STATE OF NORTH CAROLINA
DEPARTMENT OF TRANSPORTATION

June 13, 2024

SUBJECT: Environmental Permits for the Improvements to NC 150 in Catawba and Iredell Counties Division 12, **TIP: R-2307.**

Permit Site Changes between 2020 and 2024 Permitting:

PERMIT DRAWING
SHEET 8 OF 22

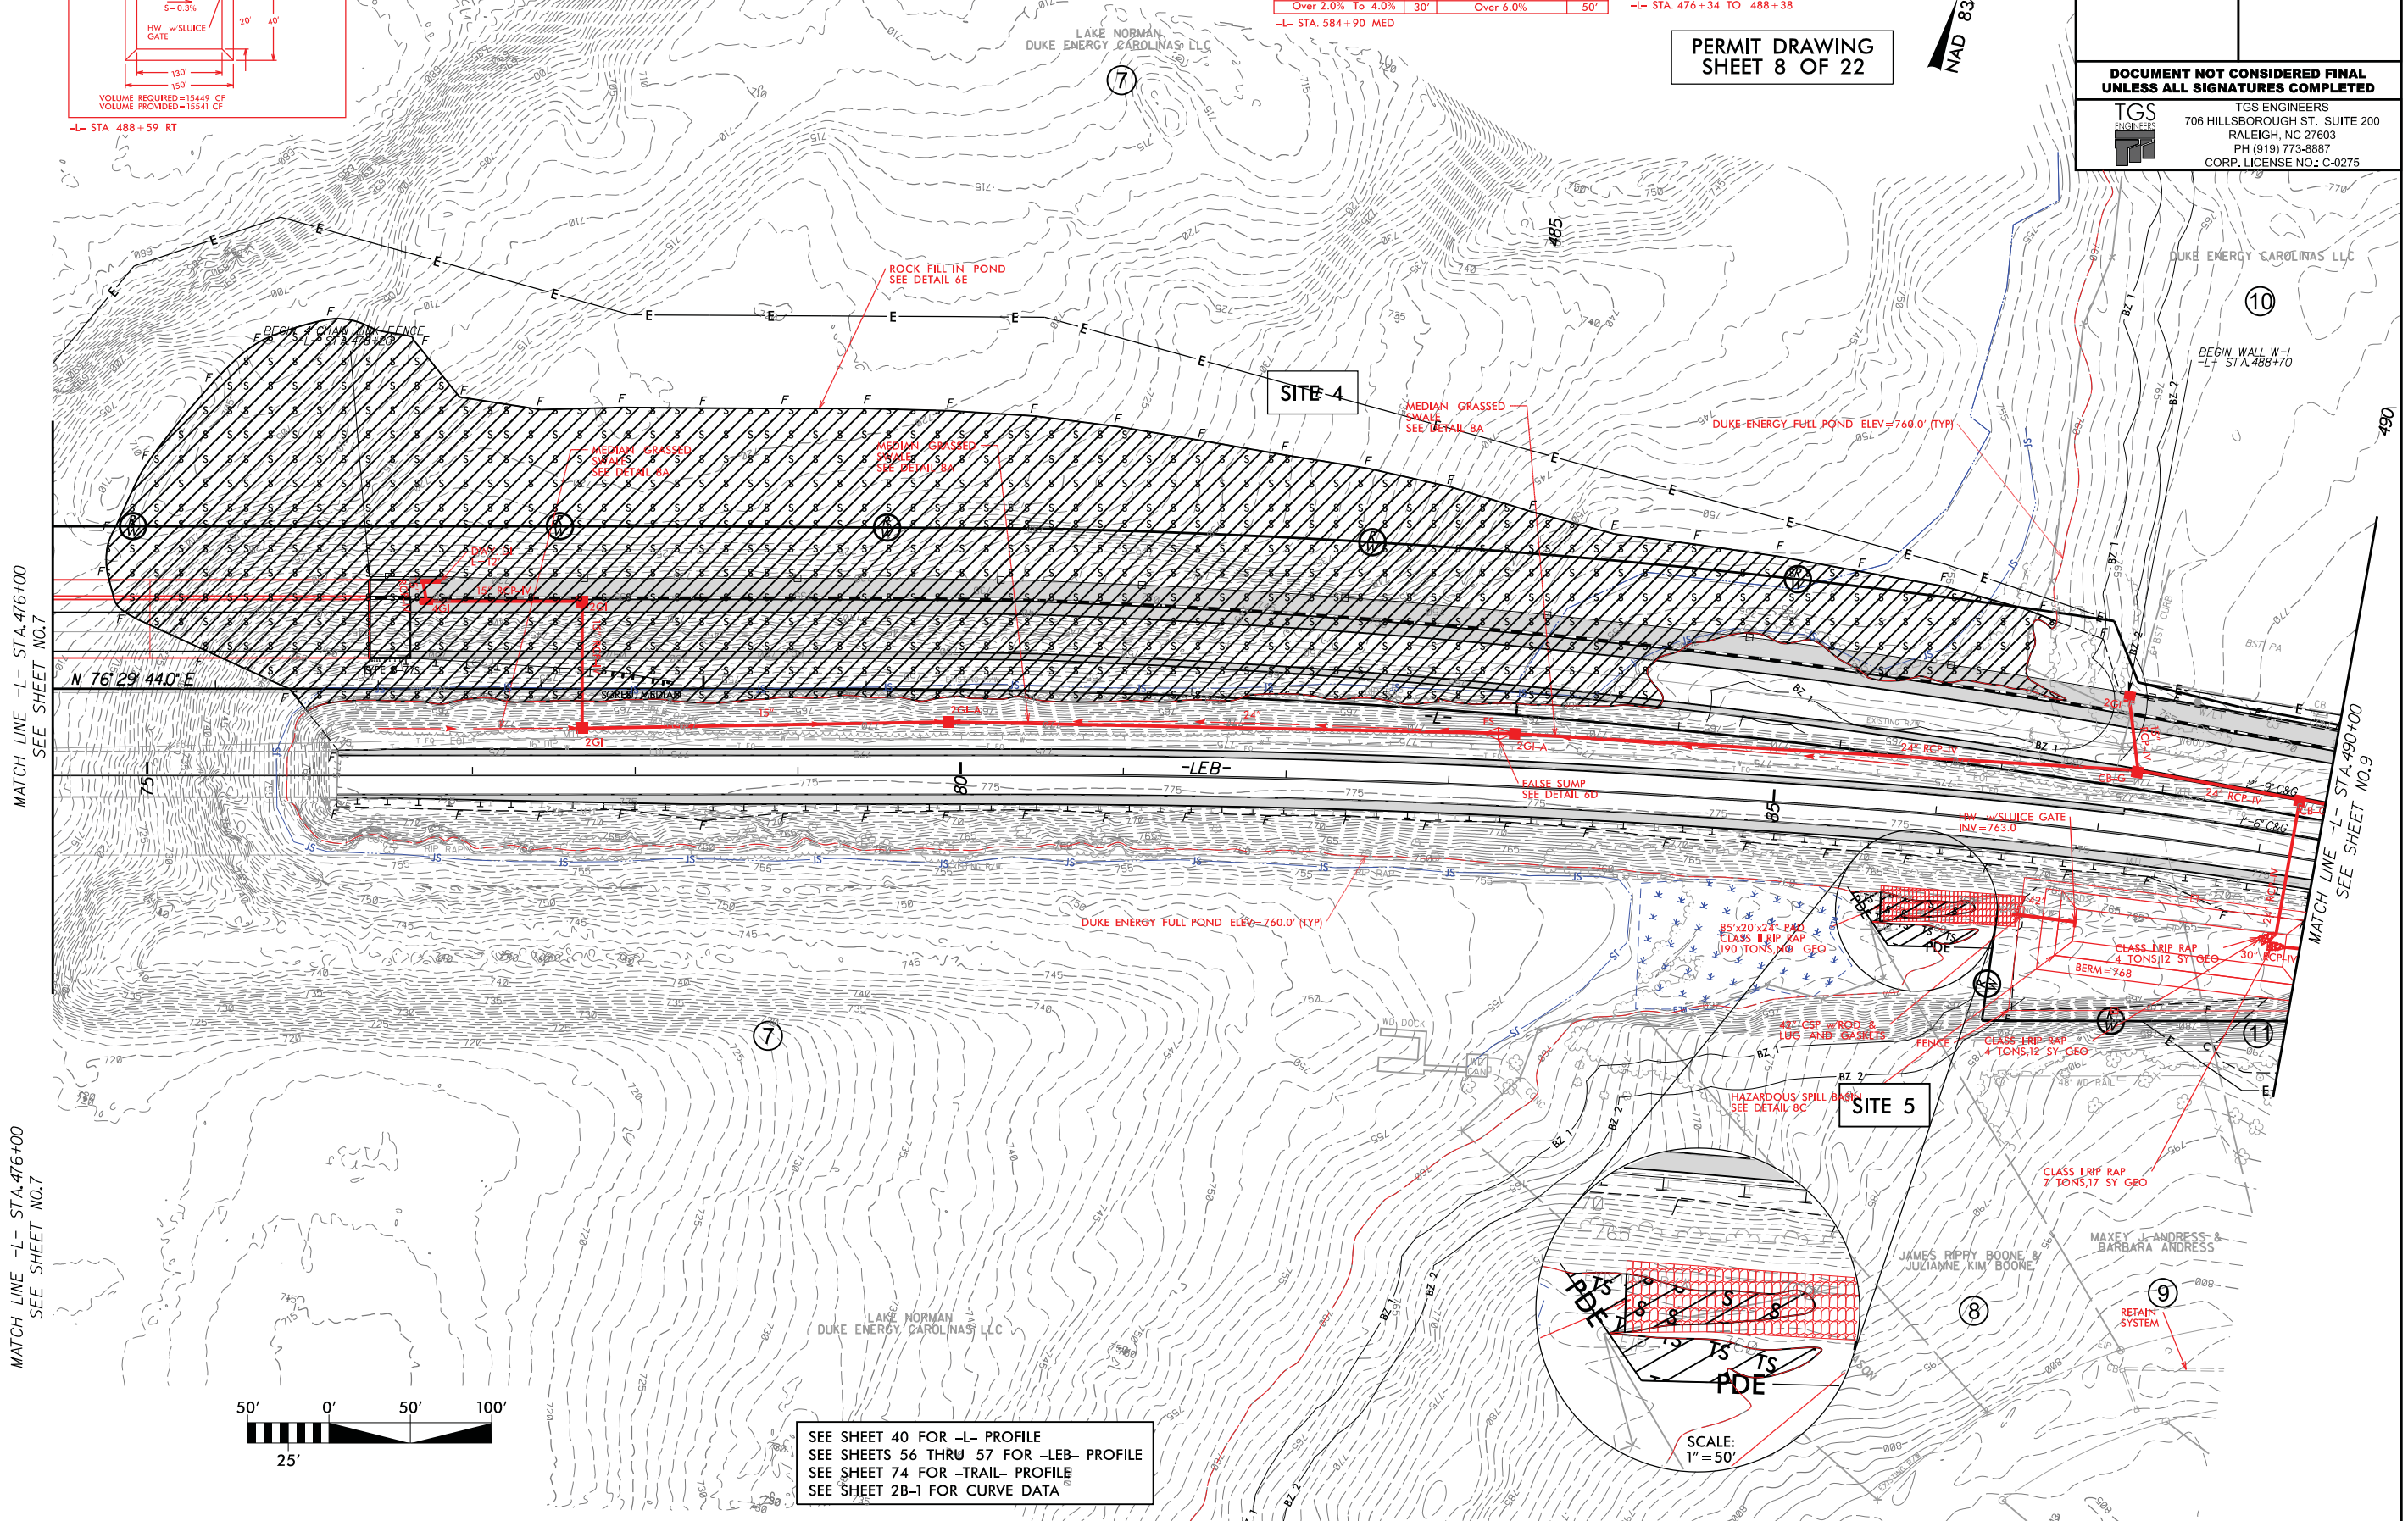
Site 4: Two temporary Surface Water Impacts were added down to elevation 750 ft on Permit Drawing Sheets 7-8. Temporary Surface Water Impacts increased from 0 to 0.162 acre.

SITE 10

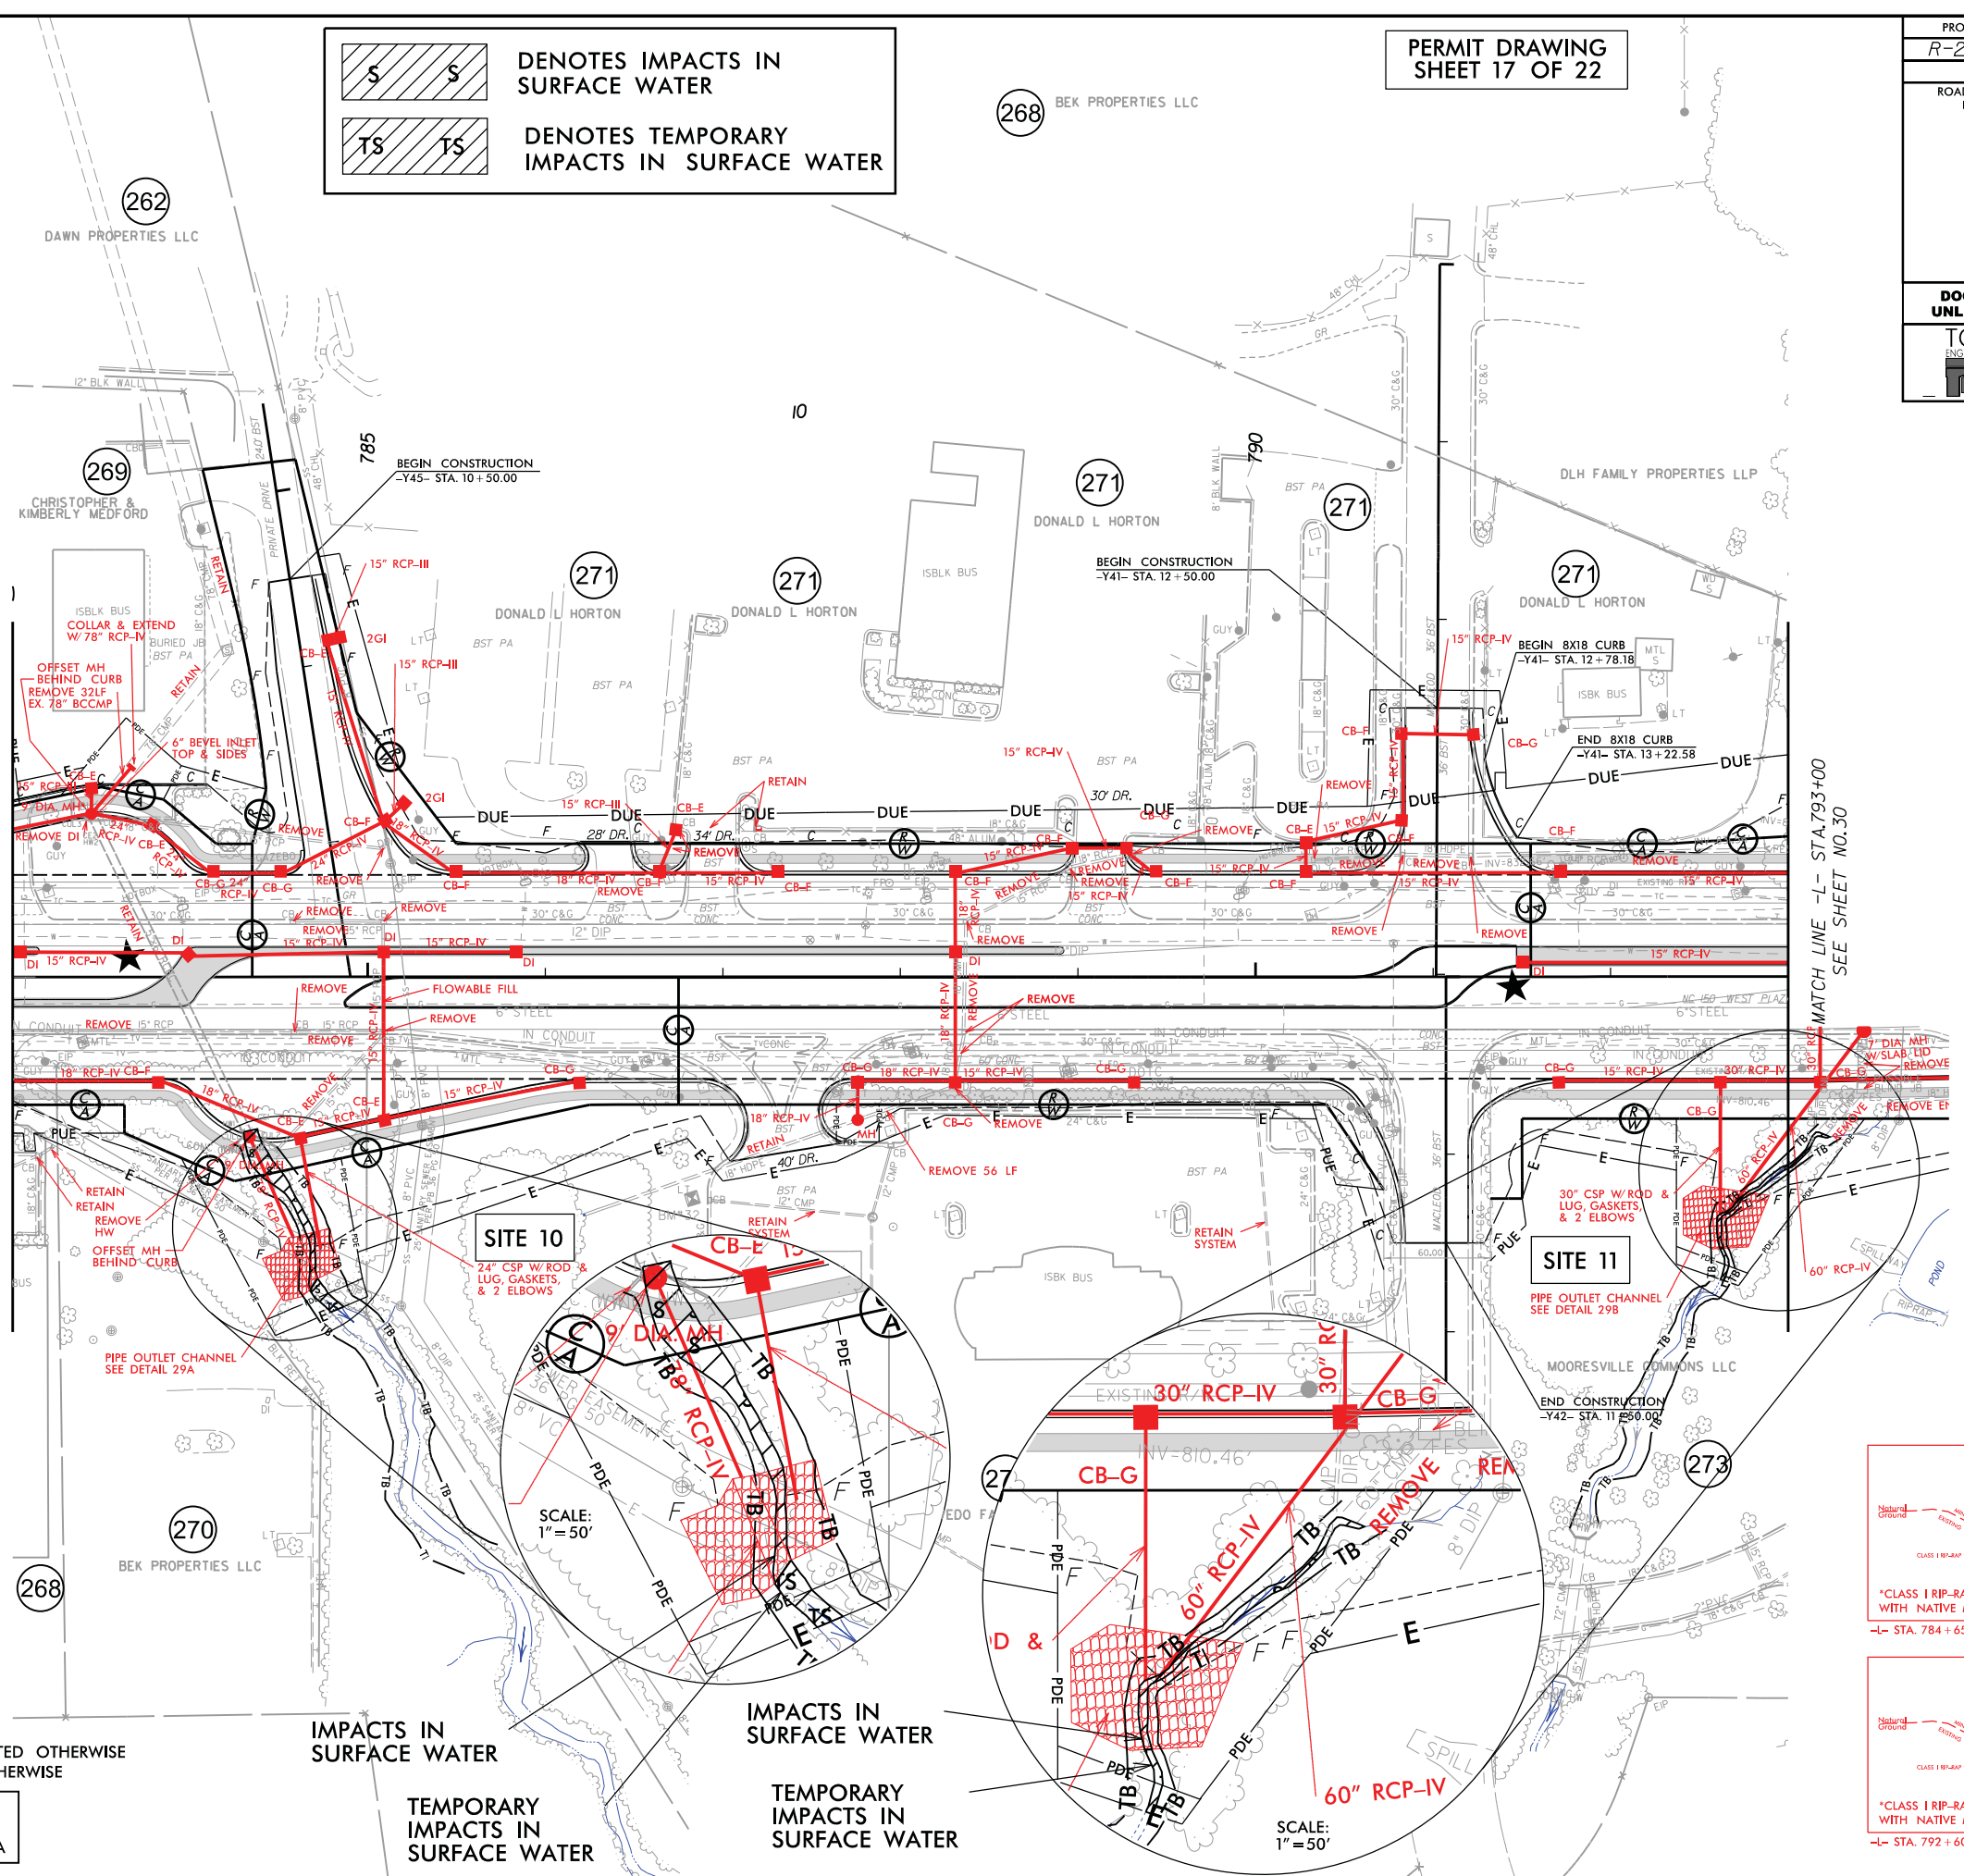
Site 10: The previous design proposed a 9' diameter precast manhole connecting an existing RCBC to a proposed 78" RCP at the downstream culvert extension at 784+50 RT (Permit Site 10). NCDOT determined that attaching a precast manhole to the existing RCBC is not feasible and would require a cast in place connection. To avoid this situation, the existing 5'W x 6'H RCBC will be extended. This will result in the outlet of the RCBC shifting 3' west of the previous 78" RCP outlet. However, the inverts, lengths, and channel layout will remain the same. There are no changes to stream impacts.
